# CONNECT MAIN STREET

## VOLUME II: CONCEPTUAL PLANS

## Public Improvement Plan Comment Statement

**Figure 7-11: Public Improvement Plans - Sheet 11**

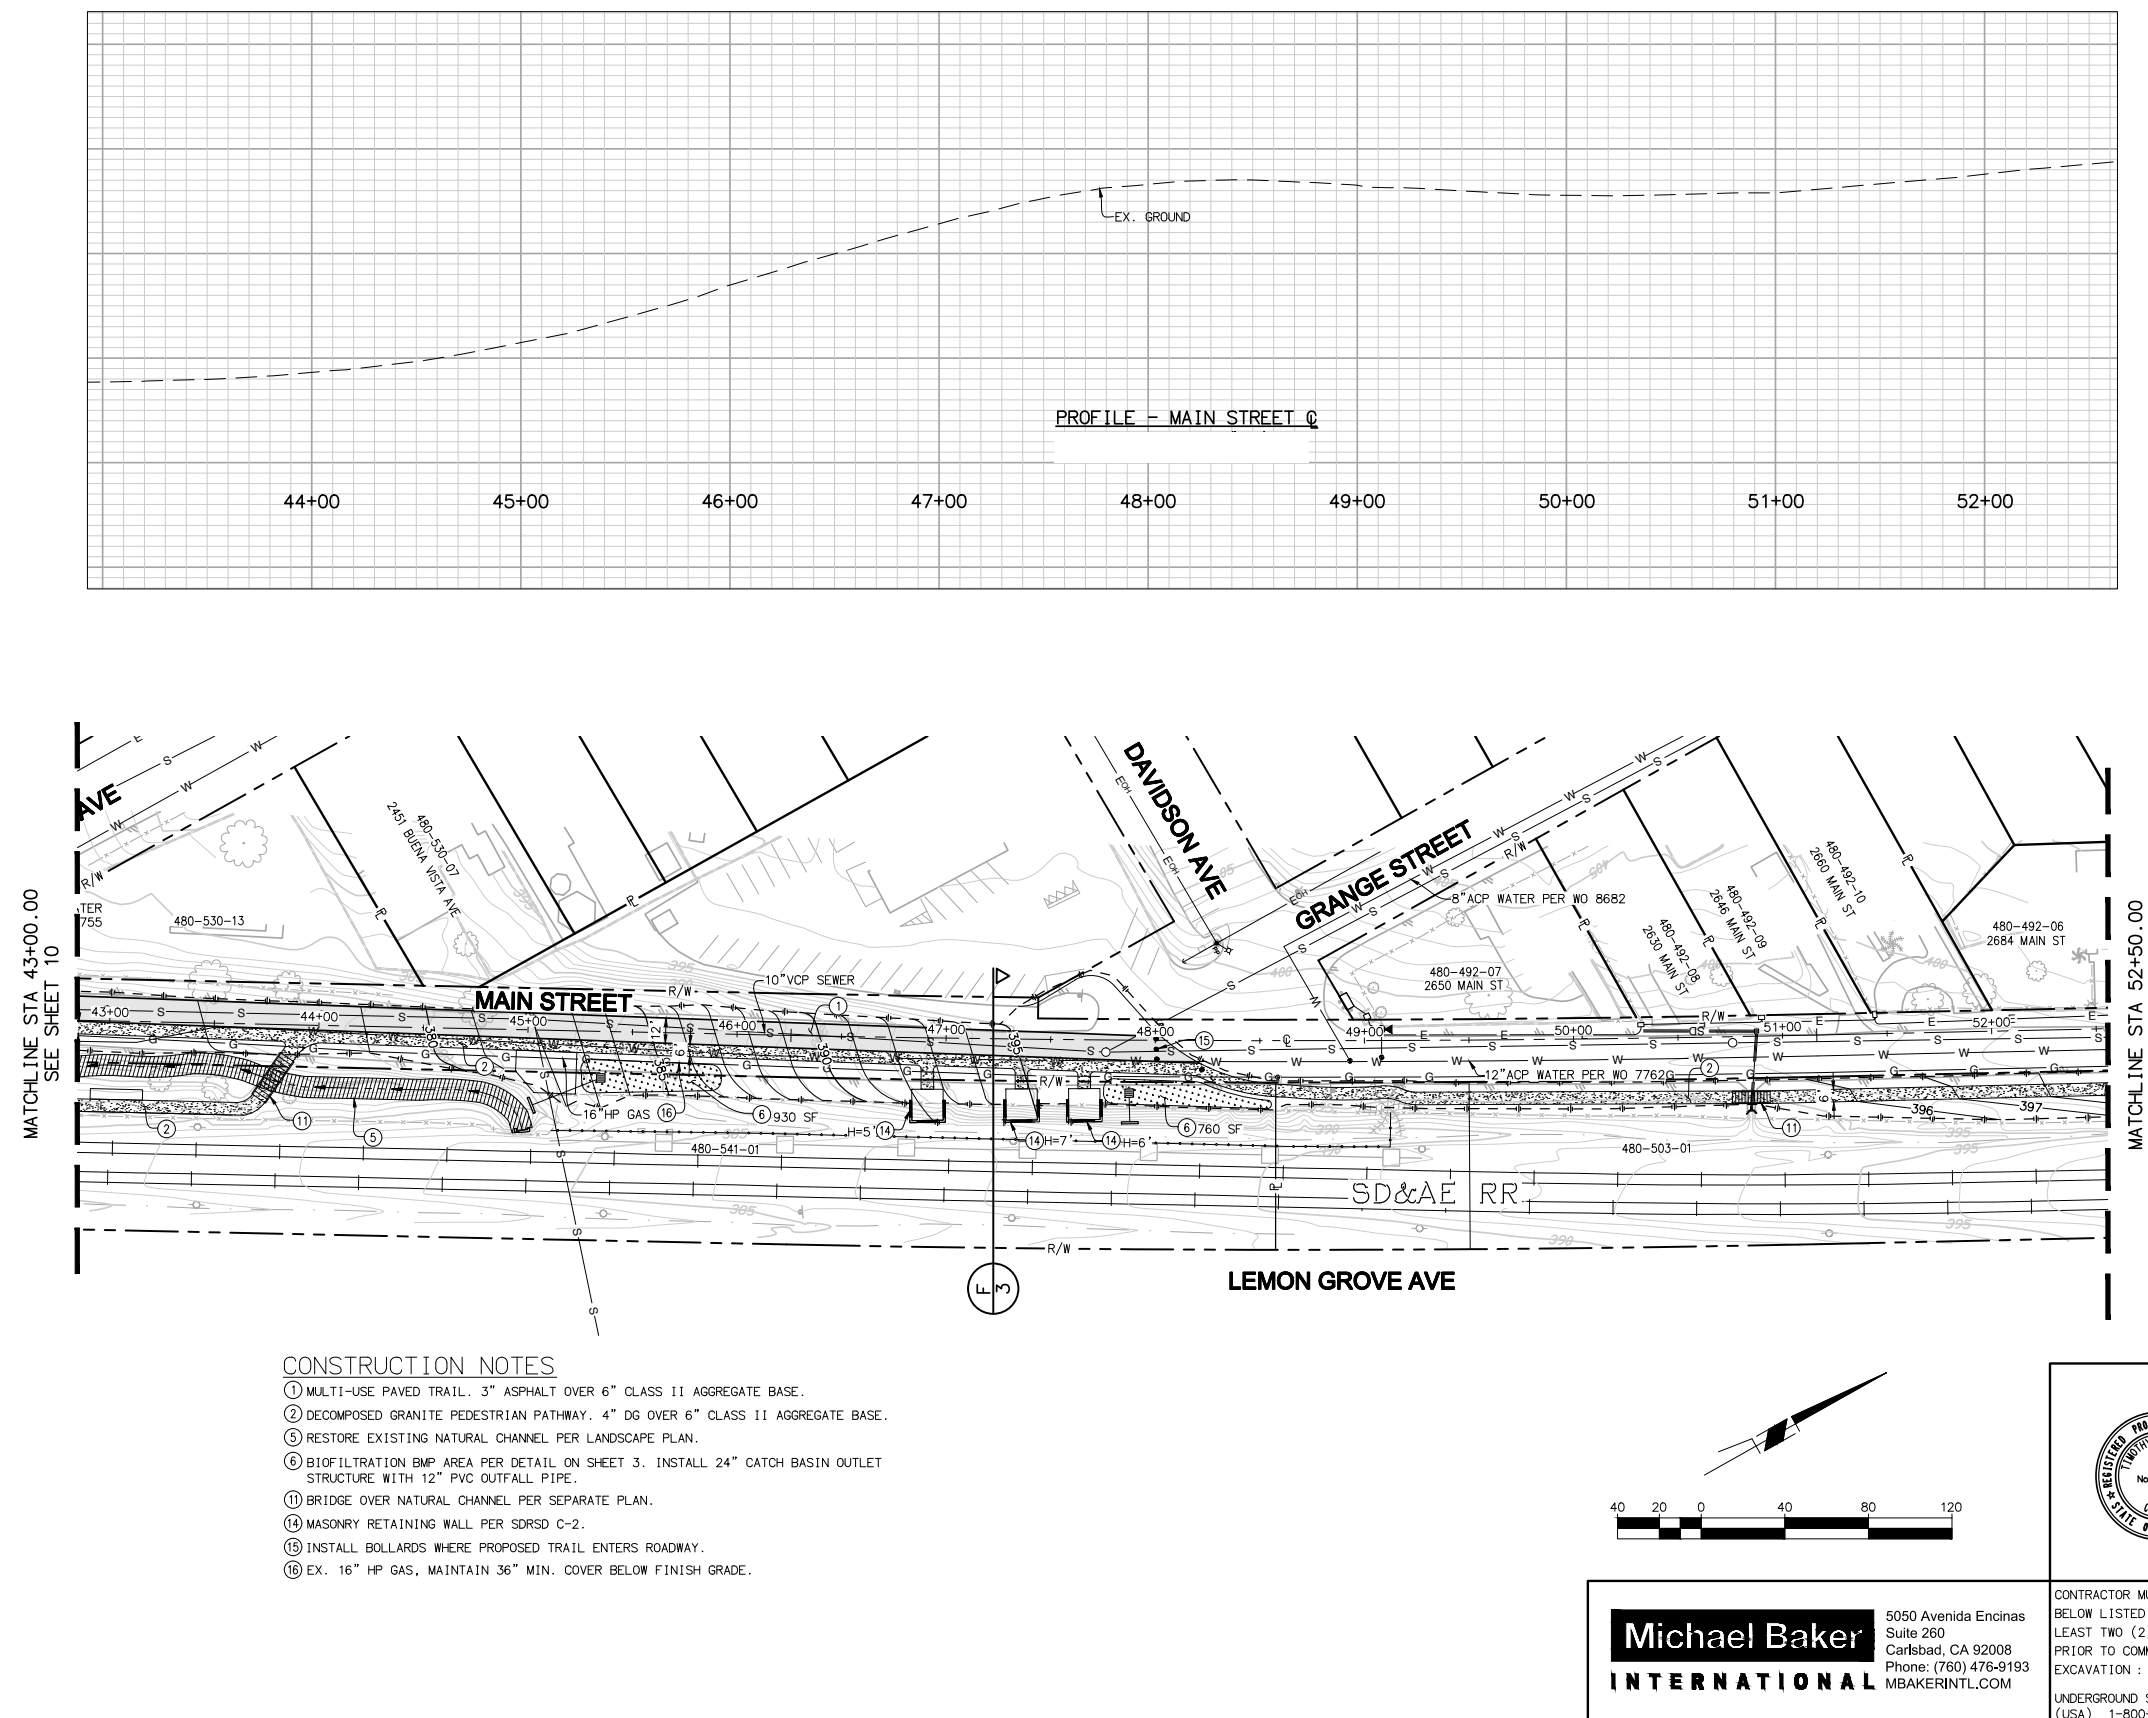
**Comment C-9:** The road profile needs to be drawn to match contours (reference sheet 11).

**Comment D-4:** How is the water quality being addressed (reference sheet 11).

**Comment D-9:** Several of the bio filters appear to have a finish grade greater than 2% (e.g., the southern bio filter on Sheet 11). Include check dams or equivalent to ensure the finish grade within bio filters is less than or equal to 2%, as required by the BMPDM.

**Figure 7-12: Public Improvement Plans - Sheet 12**

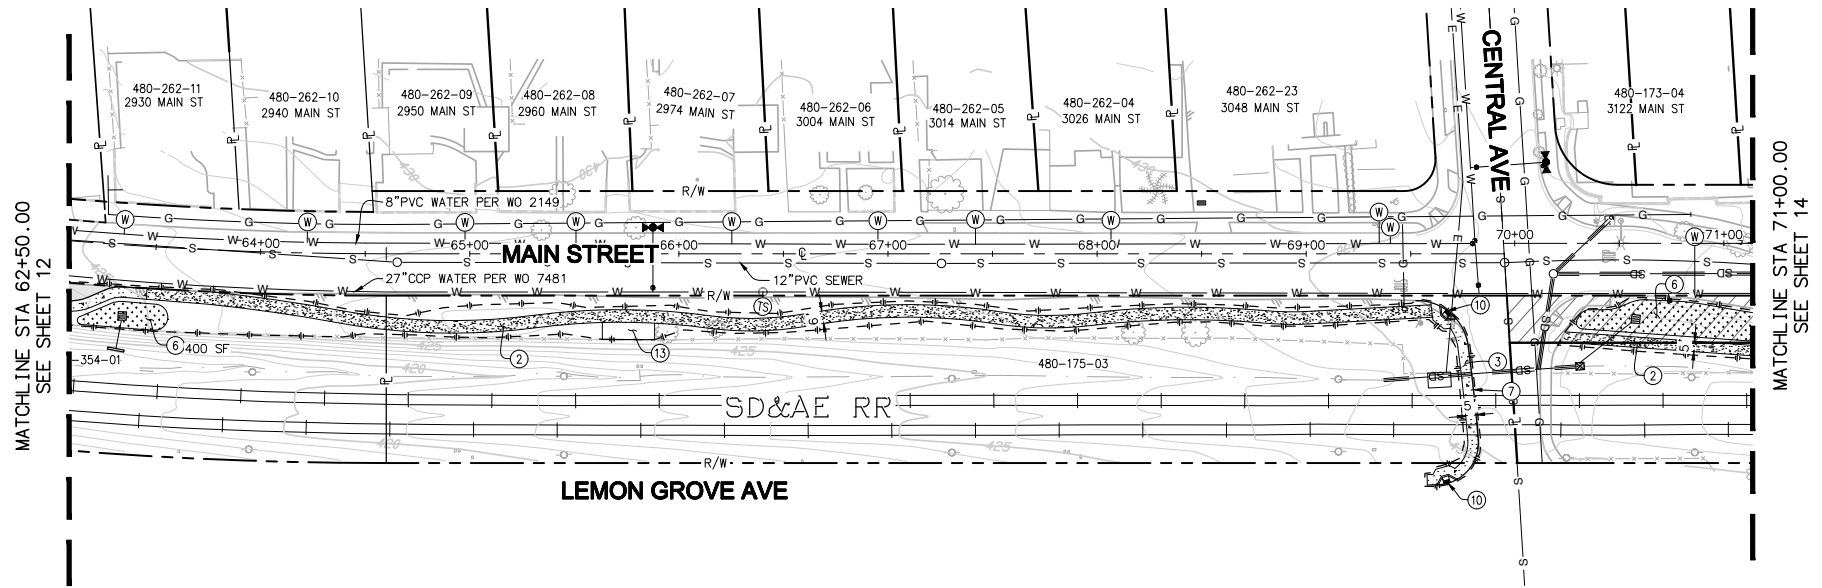
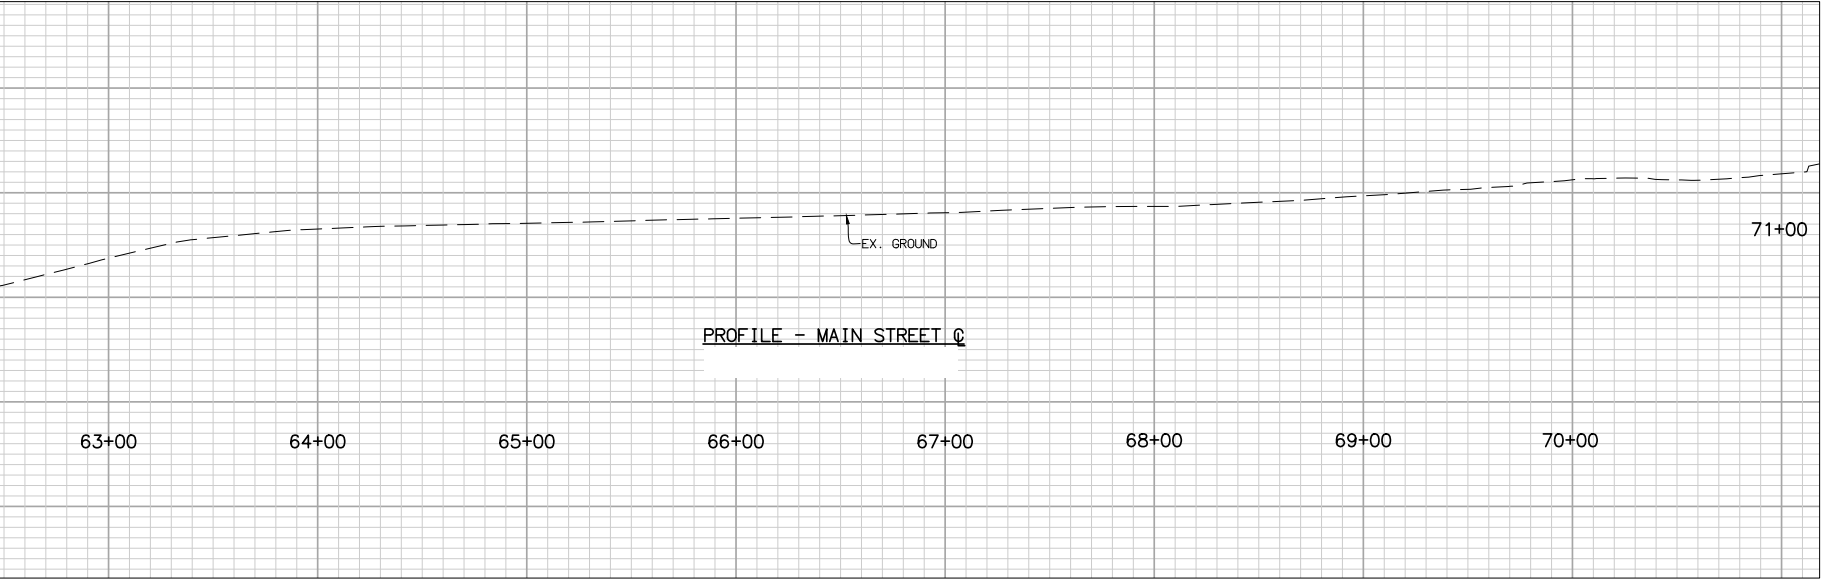
**Comment C-10:** The intersection should be refined to meet geometric design standards (reference sheet 12 and 13).

**Comment D-18:** Sheet 12 indicates channel restoration will occur, but section G-G, which crosses the channel segment marked for restoration, does not indicate that the channel will be restored in that area.

Figure 7-14: Public Improvement Plans - Sheet 14

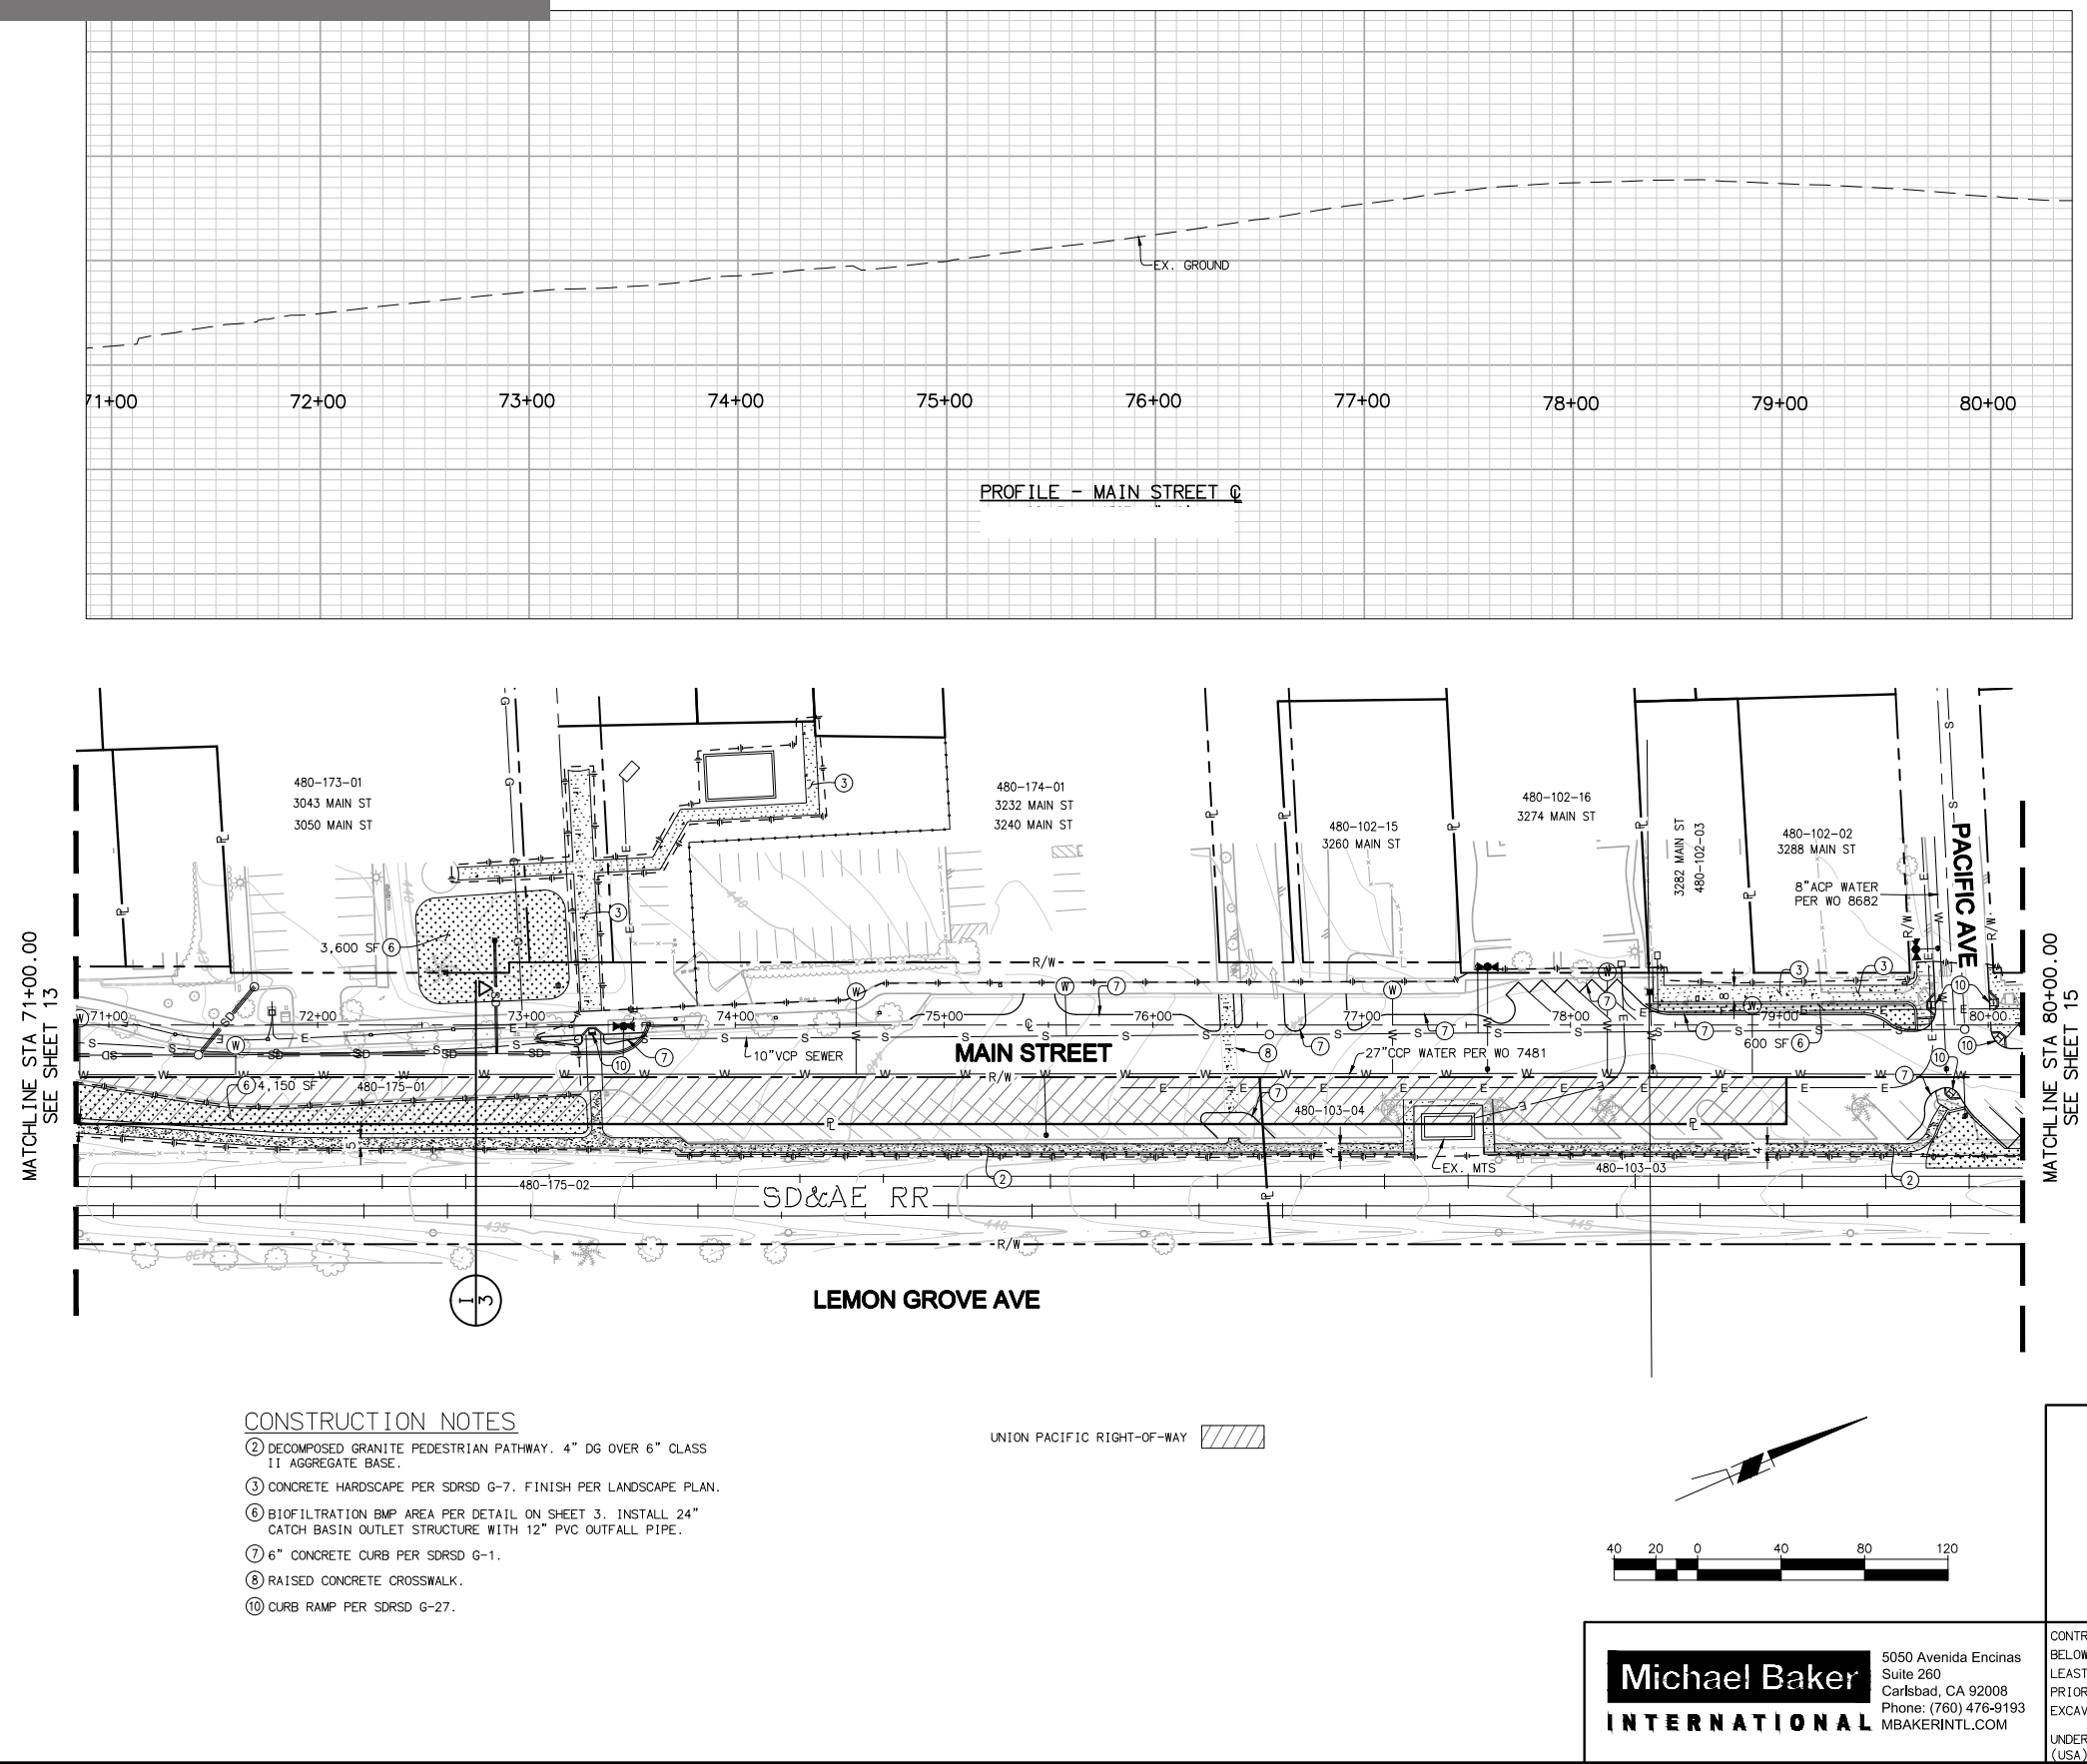
**Comment C-11:** The sidewalk width needs to be verified that it is adequate width (reference sheet 14).

**Comment C-12:** Pedestrian ramps need to be lined up better (reference sheet 14).

Figure 7-15: Public Improvement Plans - Sheet 15

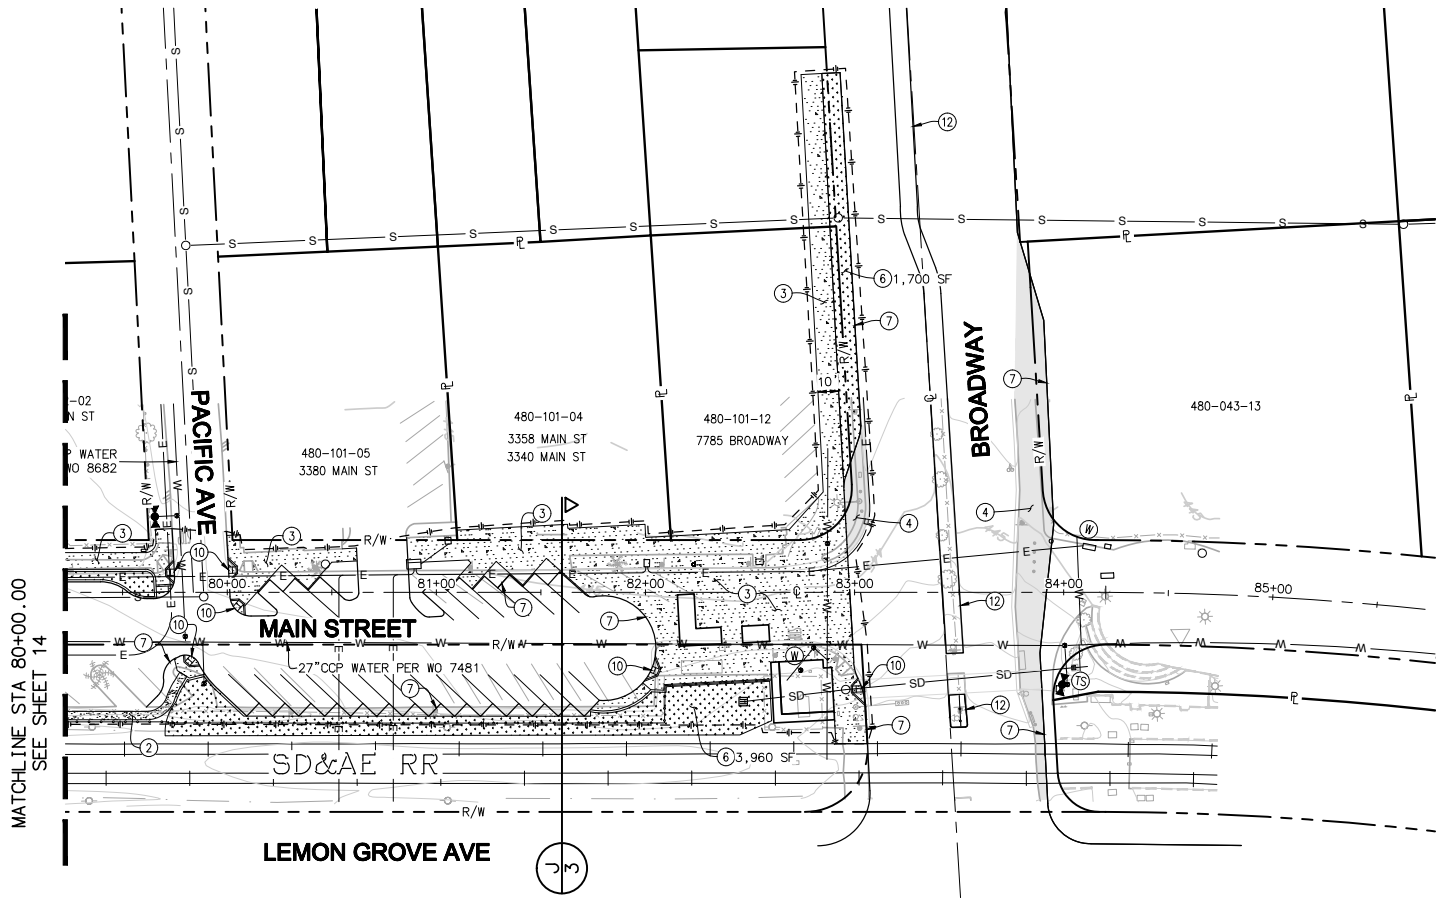
**Comment C-13:** Show the cross section with right-of-way striping (lane geometry) for sidewalk and median (reference sheet 15).

**Comment C-14:** Clearly label fire access (reference sheet 15).

**Comment S-9:** Label the two bus stop pull-out locations. Ensure the option portrayed aligns with the City Council's and City Manager's direction (reference sheet 15).
